CROSSROADS MIXED USE FILING NO. 1

COUNTY OF EL PASO, STATE OF COLORADO

CONSTRUCTION PLANS

EL PASO COUNTY FILE NO. SF 21-029

**MEADOWBROOK PARKWAY (PUBLIC)
STA. 1+00.00 TO STA. 9+65.50**

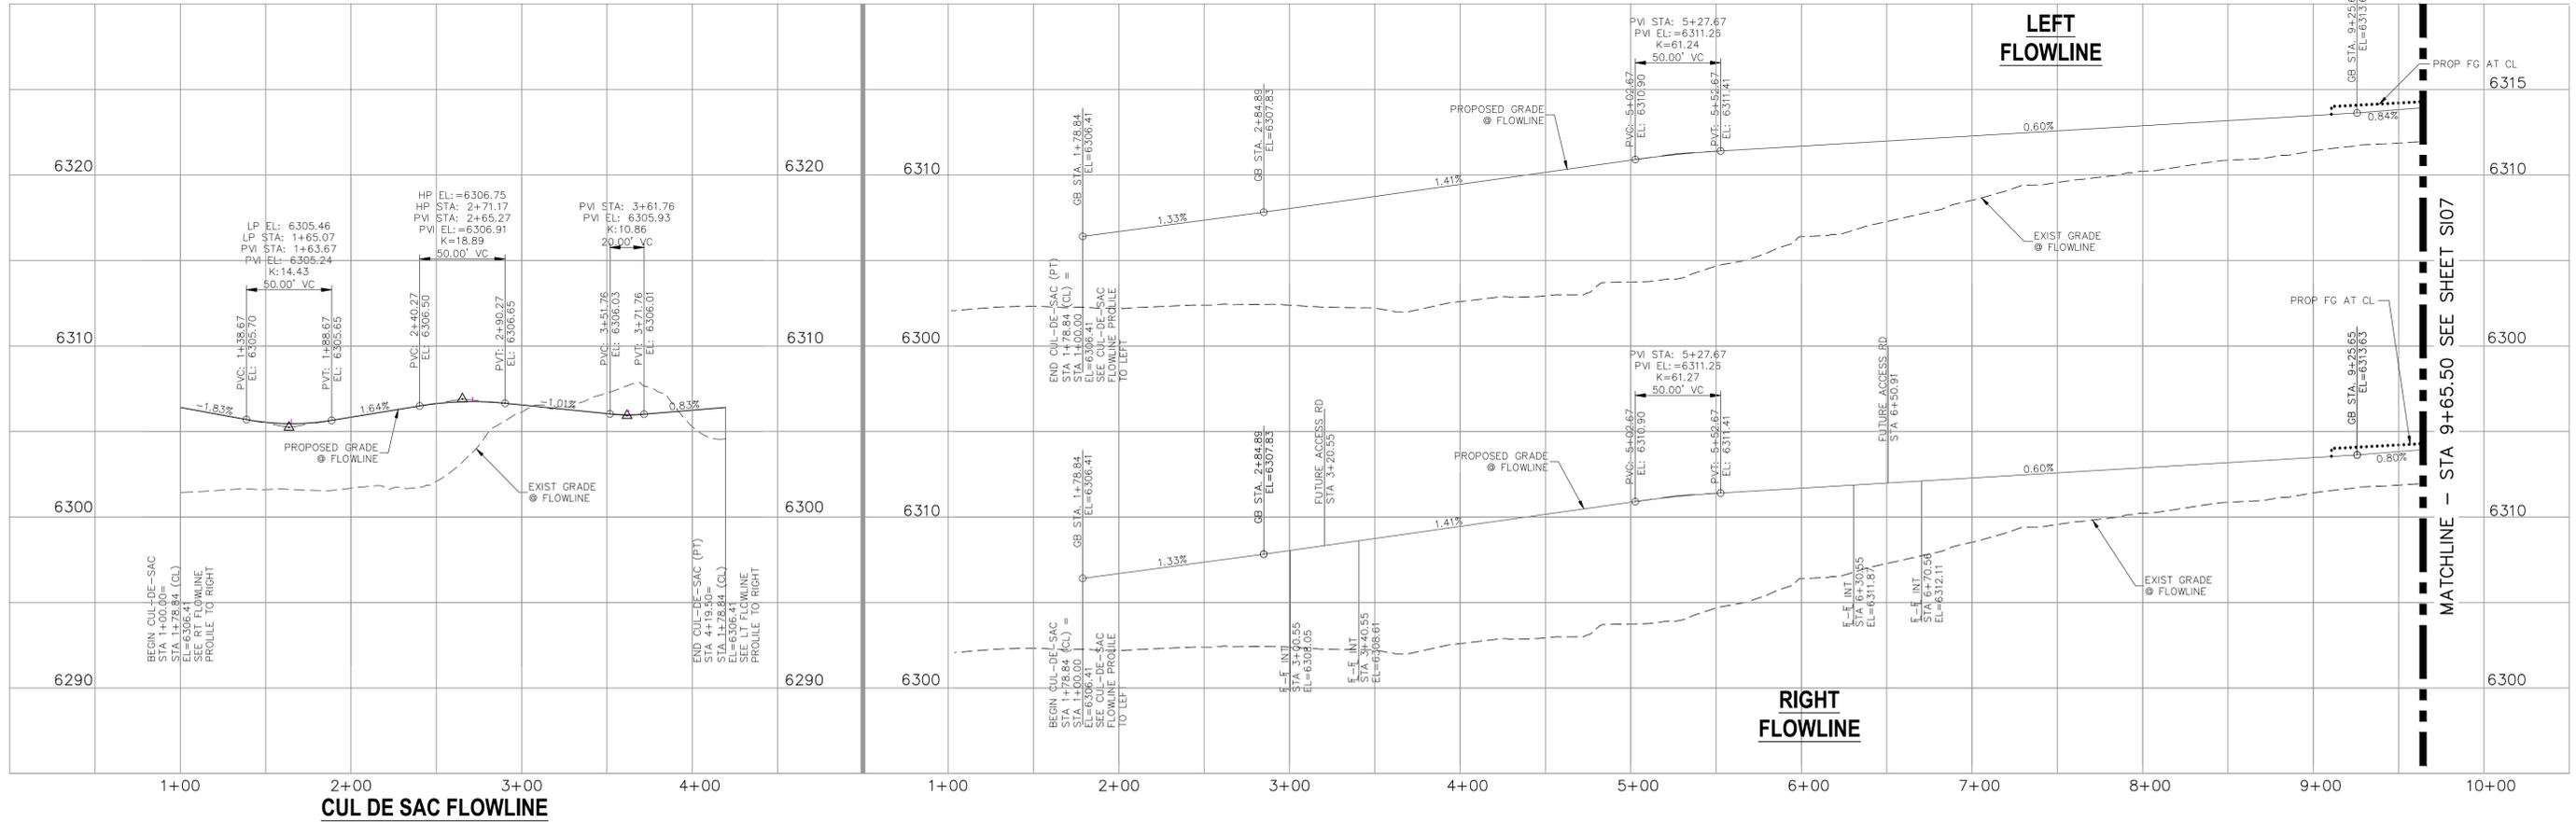
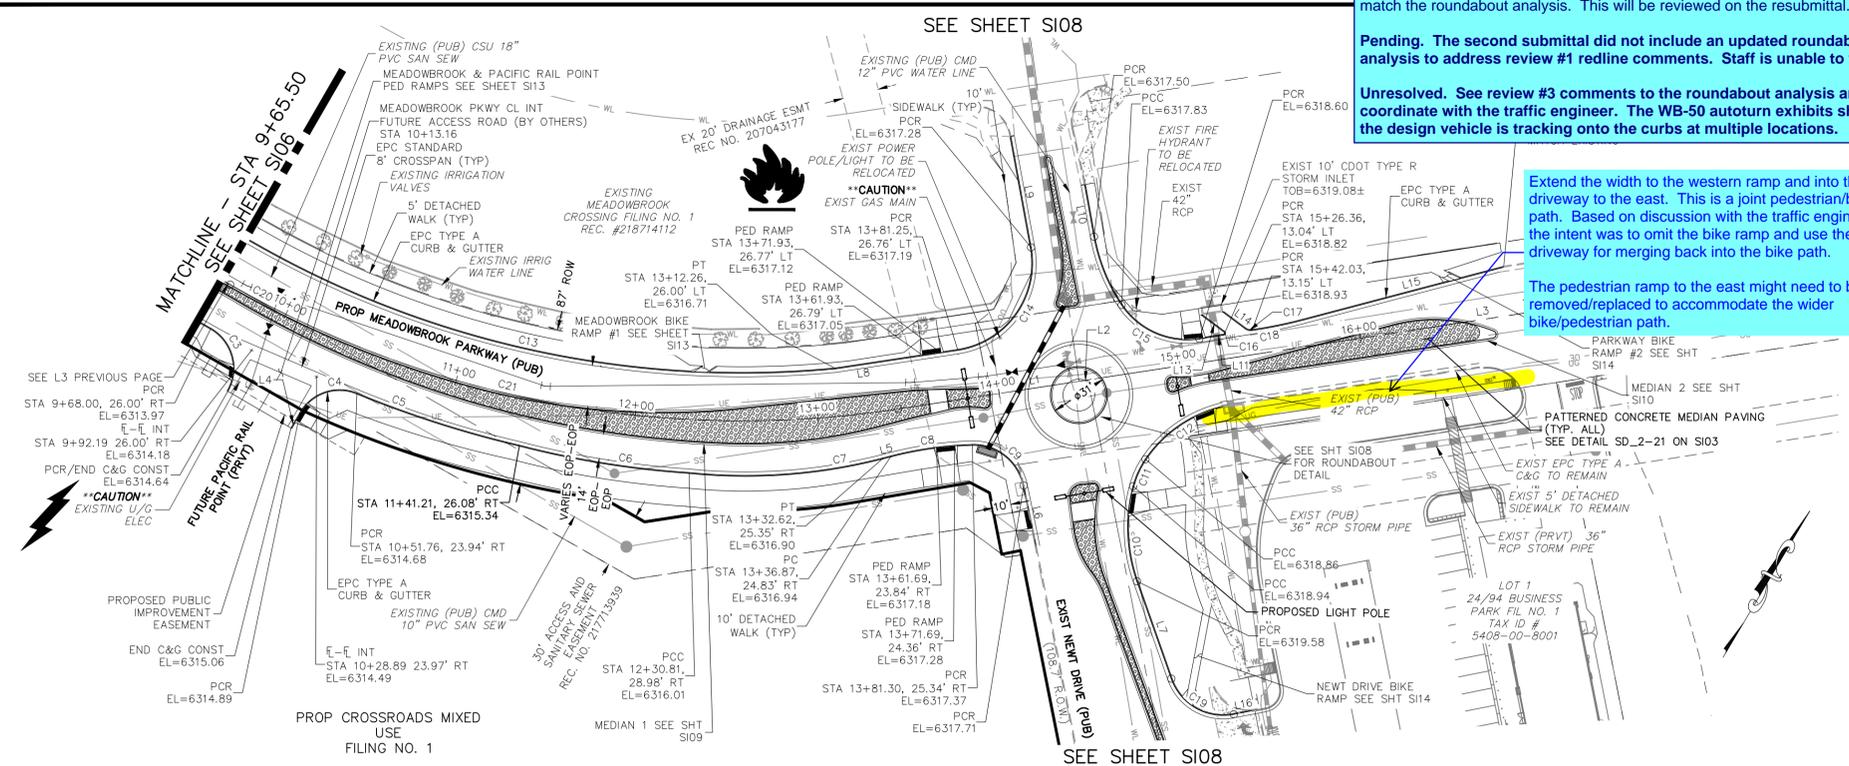
Coordinate with the traffic engineer. The roundabout configuration does not match the roundabout analysis. This will be reviewed on the resubmittal.

Pending. The second submittal did not include an updated roundabout analysis to address review #1 redline comments. Staff is unable to verify.

Unresolved. See review #3 comments to the roundabout analysis and coordinate with the traffic engineer. The WB-50 autoturn exhibits shows the design vehicle is tracking onto the curbs at multiple locations.

Extend the width to the western ramp and into the driveway to the east. This is a joint pedestrian/bike path. Based on discussion with the traffic engineer, the intent was to omit the bike ramp and use the driveway for merging back into the bike path.

The pedestrian ramp to the east might need to be removed/replaced to accommodate the wider bike/pedestrian path.

**MEADOWBROOK PARKWAY (PUBLIC)
STA 9+65.50 TO STA 16+83.21**

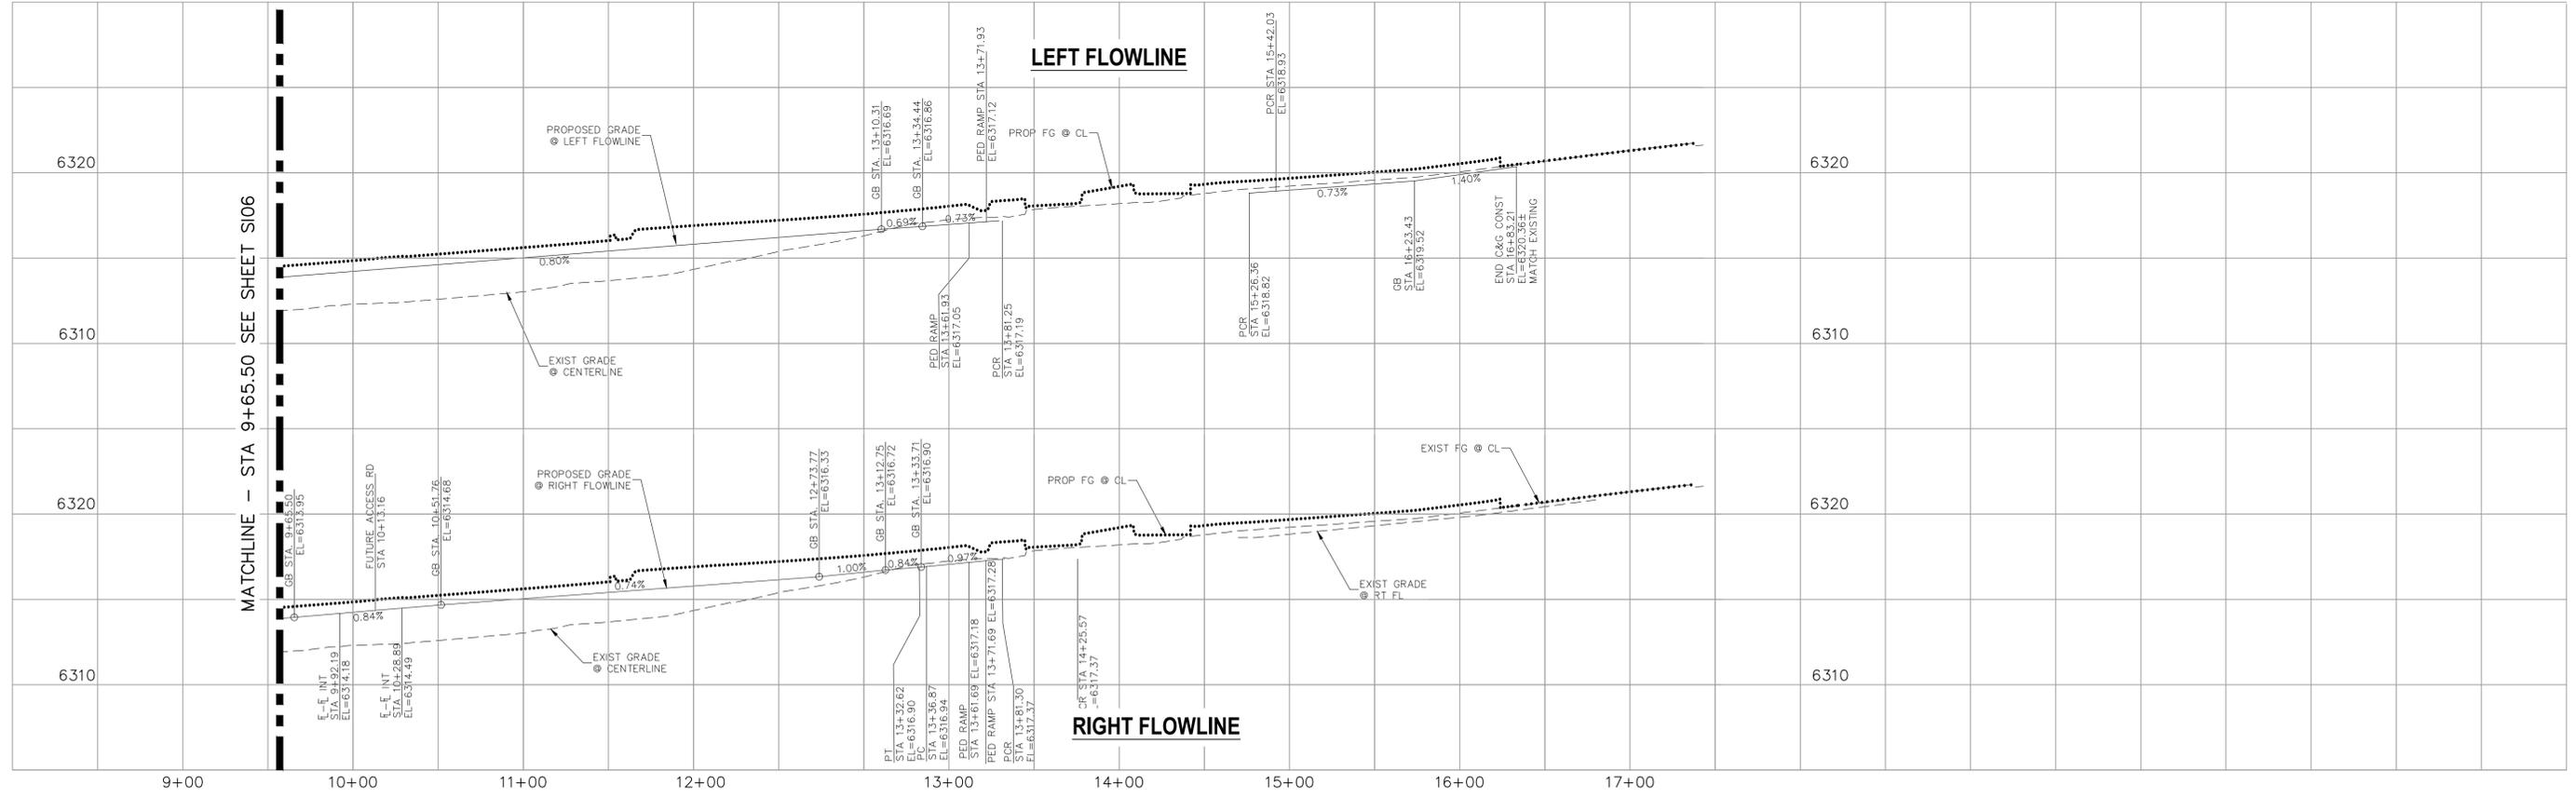
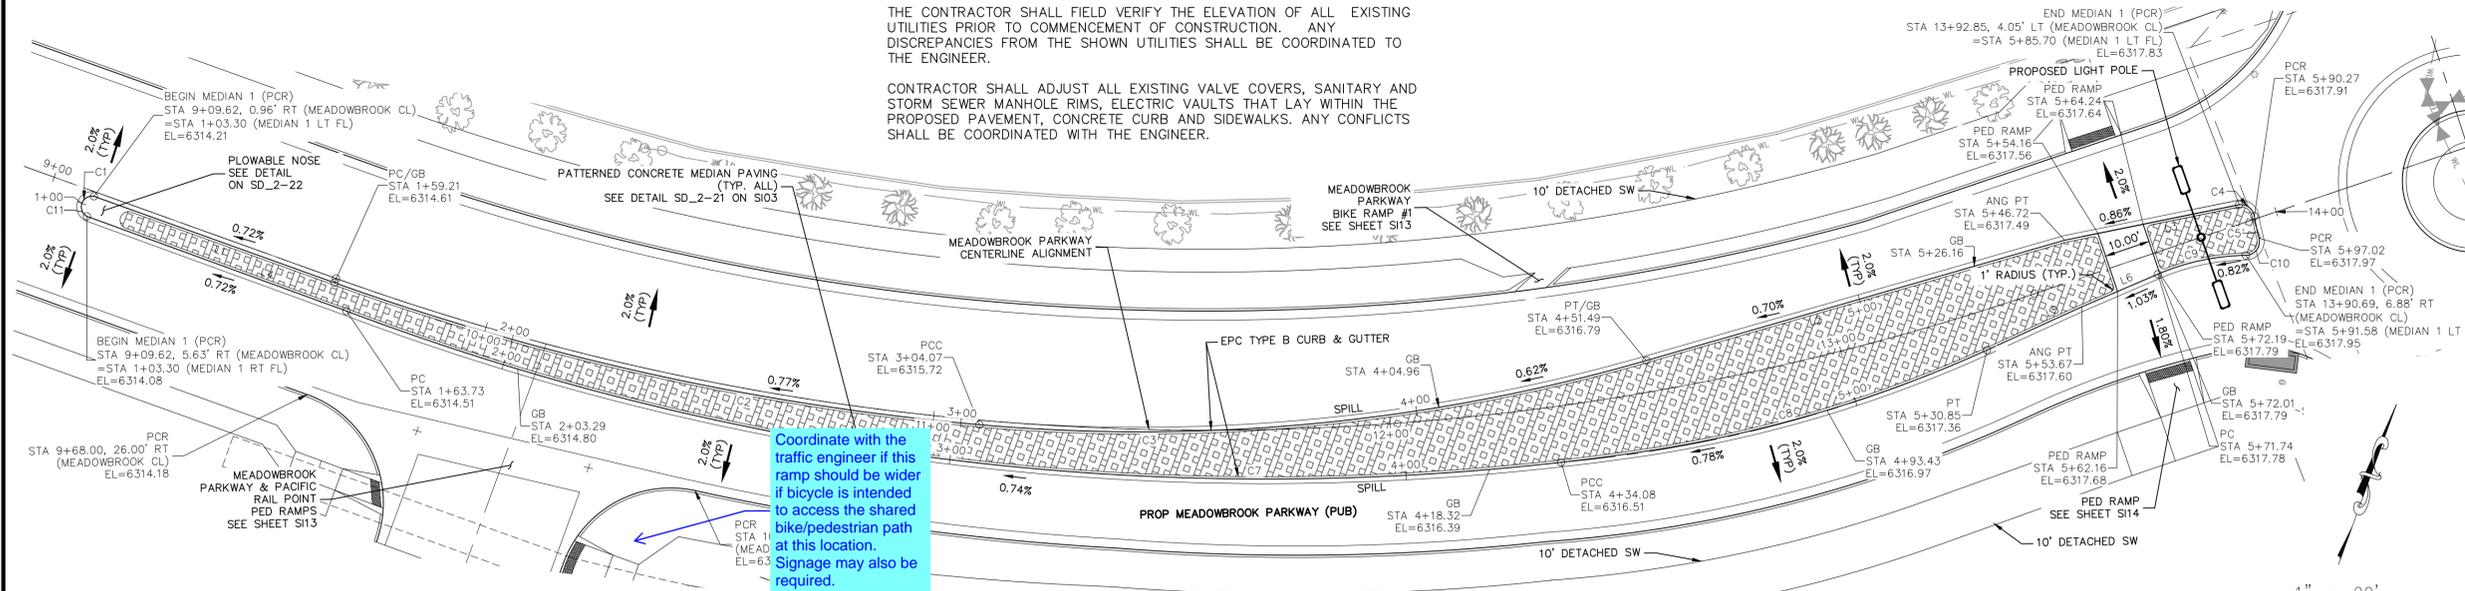
Coordinate with the traffic engineer if this ramp should be wider if bicycle is intended to access the shared bike/pedestrian path at this location. Signage may also be required.

CROSSROADS MIXED USE FILING NO. 1
 SIGNAGE AND STRIPING PLAN
 PROJECT NO. 18-003
 DATE: 02/16/22
 SCALE: HORIZONTAL: 1"=50' VERTICAL: N/A
 DESIGNED BY: CLP
 DRAWN BY: CLP
 CHECKED BY: VAS
 SHEET 12 OF 24
 S112

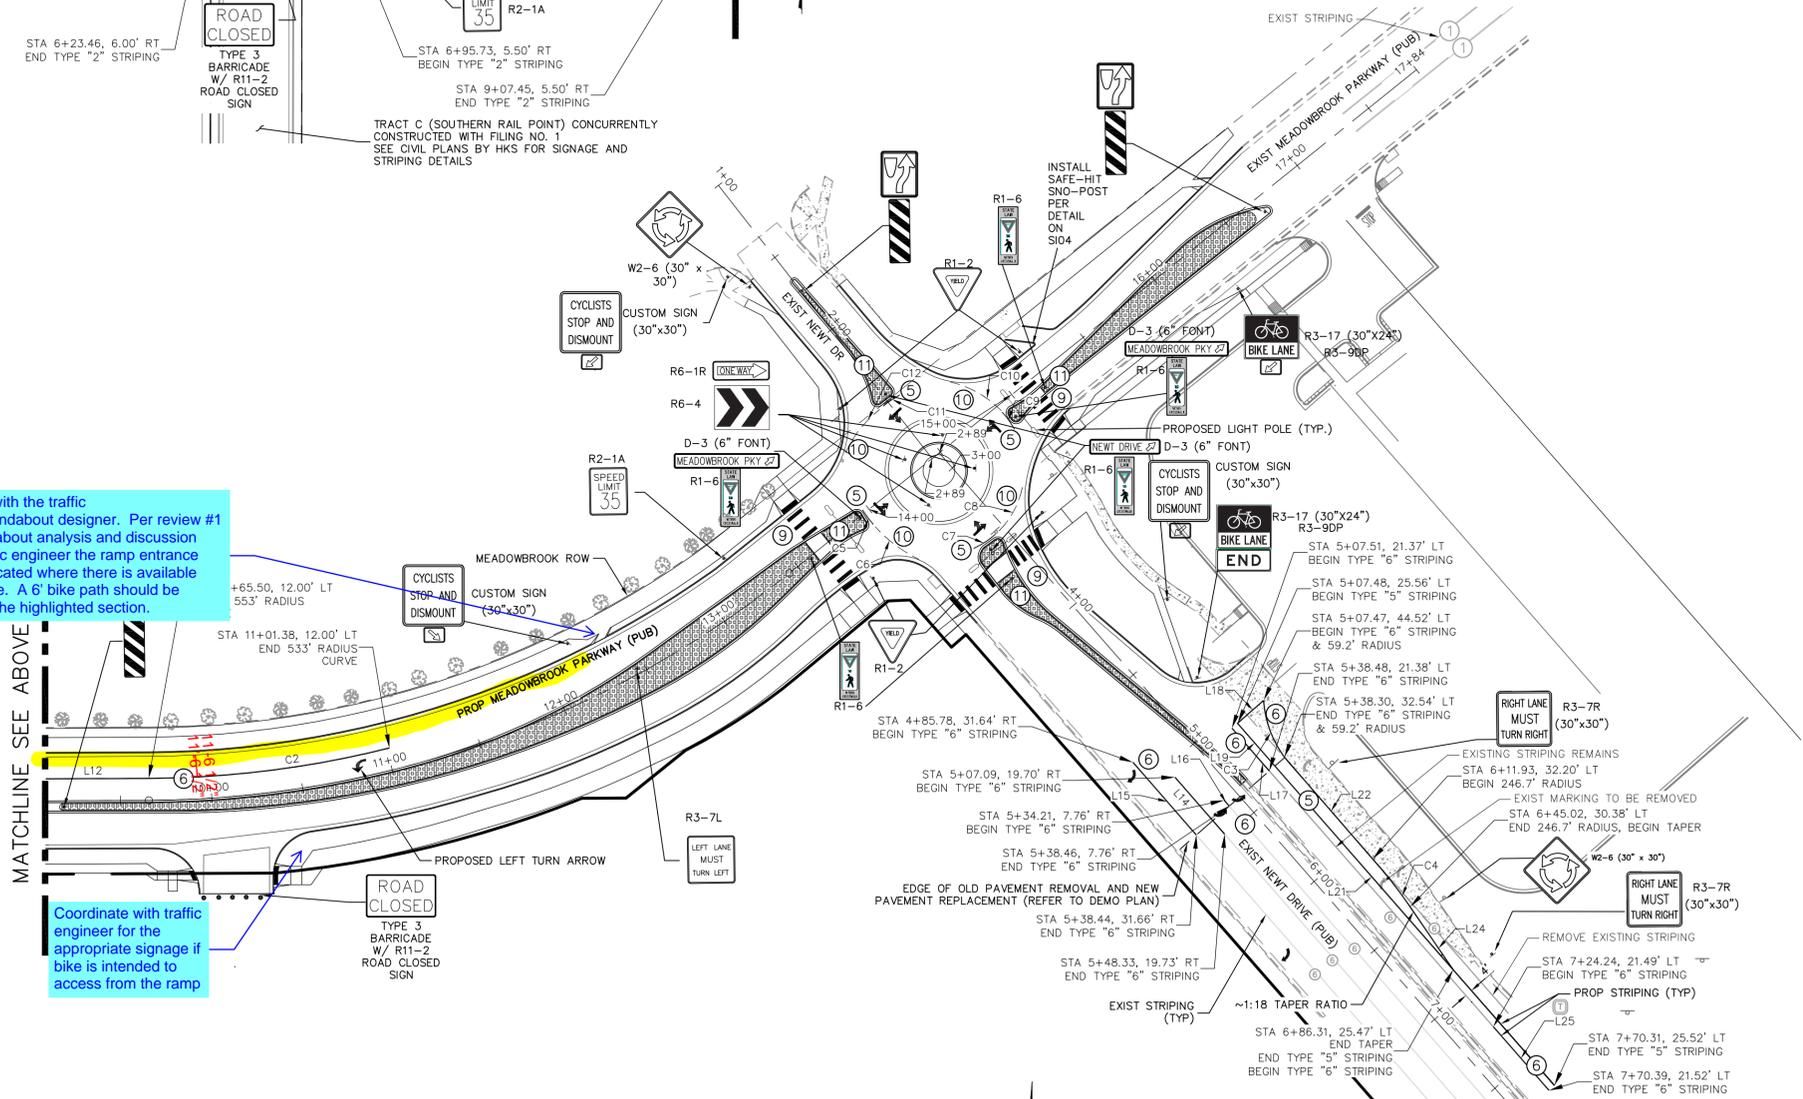
Coordinate with the traffic engineer/roundabout designer. Per review #1 of the roundabout analysis and discussion with the traffic engineer the ramp entrance should be located where there is available shoulder lane. A 6' bike path should be available at the highlighted section.

Coordinate with traffic engineer for the appropriate signage if bike is intended to access from the ramp

MEADOWBROOK PARKWAY & SOUTHERN RAIL POINT

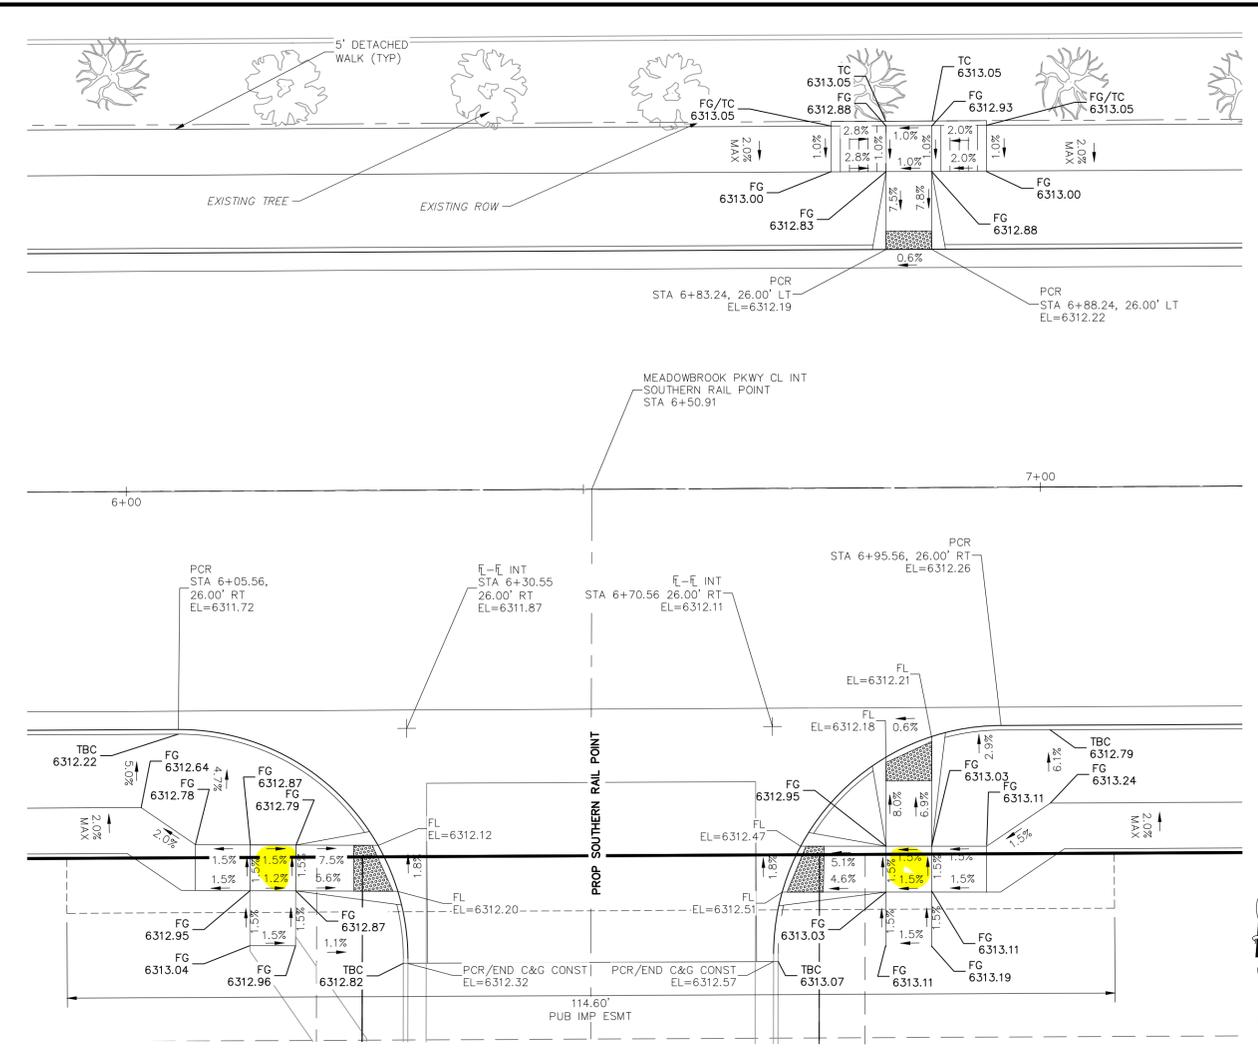
Adjust grade on all landing pad (Highlighted in yellow) to be 2.0% max at any direction (1.5 percent preferred).
Current slope of 2.25% exceeds ADA.
